TECHNICAL BULLETIN

[Issue No.] GOT-A-0042-A

[Title] Change to the CF Card Interface of the GT16 Models (Handling of the Great East Japan Earthquake)

[Relevant Models] GOT1000 Series (GT16 Models)

■ Rating plate (GOT rear face)

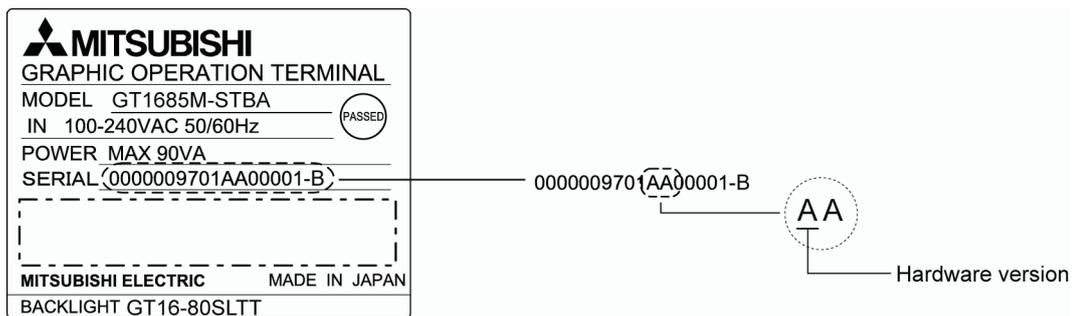
The following shows how to check the hardware version.
